**DATE** November 11, 2024  
**REVISED** May 30, 2025  
**REFERENCE** Product Design Change  
**PRODUCT** Suction Accumulators

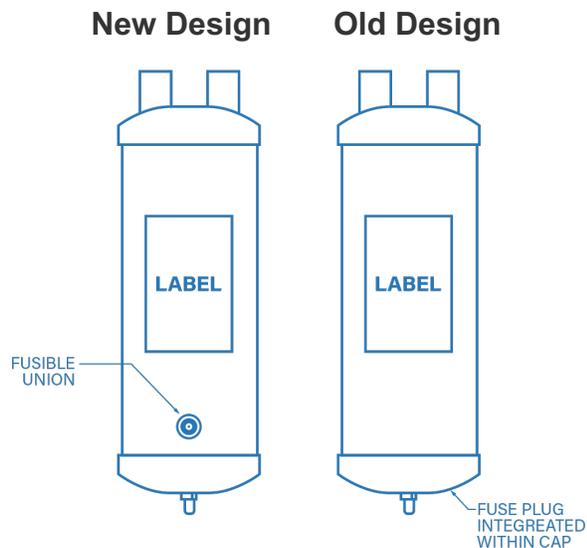
A design change has been implemented for Westermeyer Industries high pressure suction accumulator product line. New regulations for flammable A2L refrigerants require some applications to vent the fusible element outside. A 1/4" flare fusible union will be provided – rated to 430F. This requirement is to ensure any flammable refrigerant is removed from the occupied space.
